No. 238

TO ALL ROOTES GROUP DEALERS

SUNBEAM ALPINE

BOOT LOCK

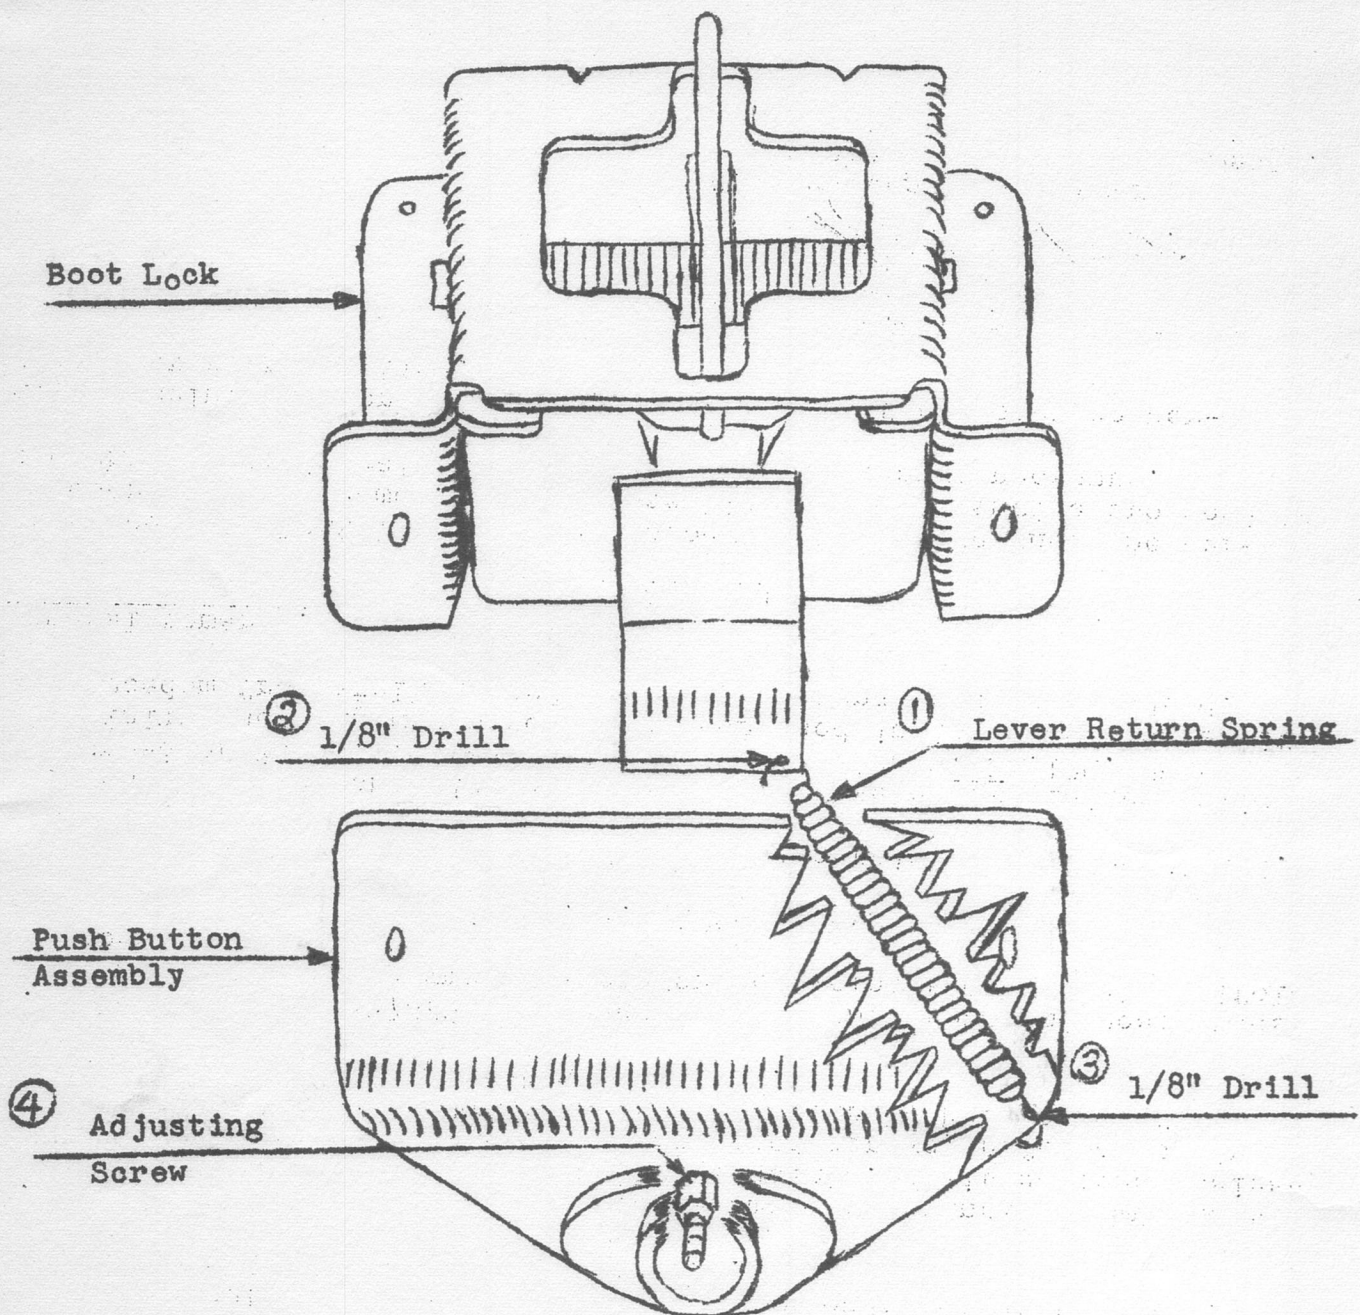
We have received a number of complaints from owners and Dealers relative to the boot lid of Sunbeam Alpines coming open when the vehicle is in motion.

Our overseas Production advises the cause of this has been relegated to the lack of sufficient tension on the retainer spring of the lock assembly itself and present production includes a higher tension spring being fitted.

To overcome this problem in service, however, attached is a diagram indicating a small modification which we know to be 100% effective in eliminating this problem.

The attached schematic is self-explanatory and we feel you should have no trouble making this slight modification whenever owners confront your location with this problem.

1. Striker Plate Spring $1\frac{1}{2}$ " Long
5 - 7 lb. Pull
2. $1/8$ " Drill in striker plate
3. $1/8$ " Drill in lock housing
4. Striker Plate Screw to be adjusted
so that a clearance of .020 remains
between plate and screw.
